CDM-MP58-A20

Information note on proposed draft
guidelines for determination of baseline and
additionality thresholds for standardized
baselines using the performance-
penetration approach

United Nations
Framework Convention on
Climate Change

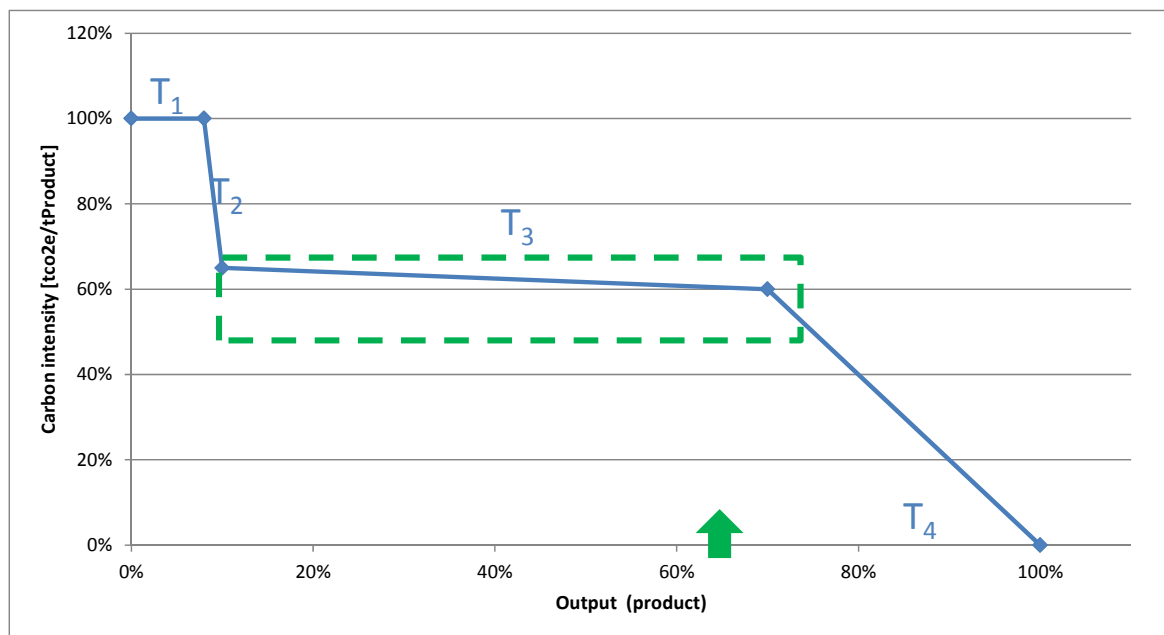
10. This difference in the shape of the curve is then used to define the threshold values.
11. However, the Methodologies Panel is of the view that these assumptions may not hold in all situations, because real life situations may differ from the theoretical and idealized curve displayed in the guidelines and display significant inhomogeneity challenging the appropriateness of selecting the common practice case with the proposed procedure. Spotting heterogeneities in carbon intensity seems not to be a robust indicator for differentiating additional from non-additional technologies.

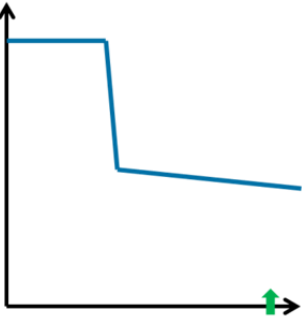
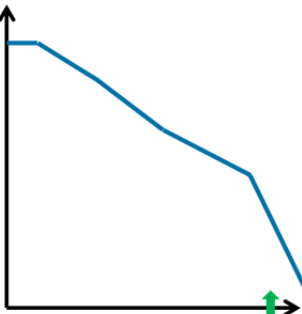
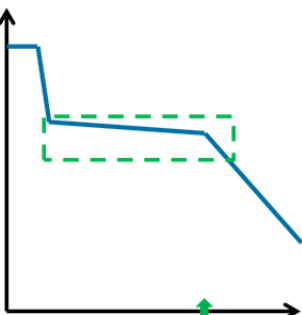
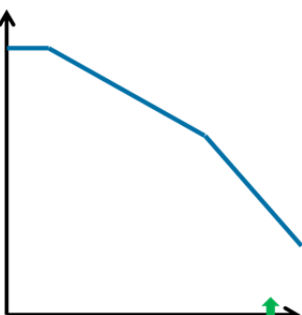
13. The following example illustrates how the proposed approach may lead to results that are rather counter intuitive: Here four different technologies are plotted T1-T4. The proposed approach identifies the segment of low “slope”, the “common practice segment (green box). From this, the threshold is derived (green arrow) and all technologies on the right hand side of the arrow would be (potentially) additional, that is T4.

14. It seems rather challenging to imagine that a technology that covers 30% of the market would be deemed additional without further investigation. According to the procedure this would be the case even if T4 covers 45% of the range. This would be particularly counter intuitive if all recently built plants in the host country would have used the technology T4. This point illustrates that the vintage of technologies should probably also play a role especially for Greenfield project activities.

15. Also please note that the proposed approach is also very sensitive to small changes in the dataset: If technology T2 which covers only 2% would not be present in the market, proposed approach could not be applied and the default threshold of 90% would need to be applied instead of the 65% with T2.
